Project No. 1775927.L02.V1

REQUEST FOR TECHNICAL AMENDMENT TO CONDITION 3.5.5

Golder Associates Ireland Limited (Golder) has been retained by Integrated Materials Solutions Limited Partnership (IMS) to provide engineering consultancy services in relation to the Hollywood Landfill at the Naul, Co. Dublin. Hollywood Landfill operates as an inert landfill under Waste Licence W0129-02. This letter constitutes a formal submission to the EPA for filling to formation with Category A inert fill in the south-east corner; this would be as opposed to using site won material as per Condition 3.5.5 of W0129-02 which states:

PROJECT		
LANDFILL DEVELOPMENT		
SHEET TITLE		
EXISTING CONDITIONS		
PROJECT No.	DRAWING No.	Rev.
1775927	01	A
SCALE		1:2,000 A3

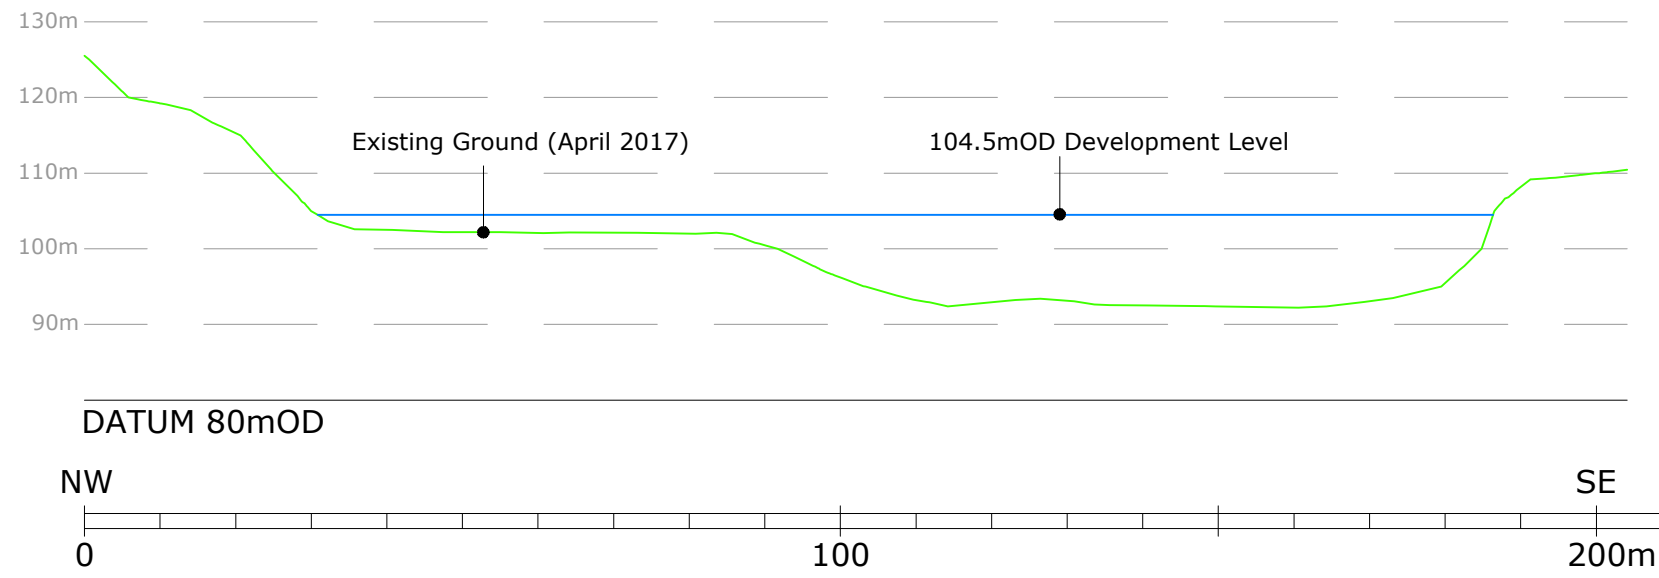
The objective of IMS is to develop the remainder of the void space at the Hollywood Great facility in a phased manner over the next few years. A large pond is situated in the south east corner of the site which will require infilling before any developments works in this area can commence.

The presence of this pond which extends below the minimum formation level stipulated in W0129-02, is linked to the previous quarrying operation at the site which was carried out under the previous ownership. As the Site is no longer used for quarrying purposes, there are no site won granular materials available to infill this pond to formation level. As such, Condition 3.5.5, in its current form, presents a barrier to future development of the site and it is not currently possible to prepare a Request for Approval (RfA) for filling this area or subsequently a Specified Engineering Works (SEW) proposal for the construction of the next phase of development. This necessitates this request to the EPA for a technical amendment to Condition 3.5.5 of the licence to allow the use of clean Category A inert fill to backfill the pond to the specified formation level of 104.5 mOD.

It is proposed to import Category A materials for use as backfill for the ponded area in the south east corner. The volume of the pond void to be filled to the formation level of 104.5 mOD has been calculated to be 153,300m³ which equates to approximately 306,600 tonnes using a conversion factor of 2 from m³ to tonnes. Drawings showing the existing site conditions in the south east corner where the pond is situated and associated cross sections are attached to this document.
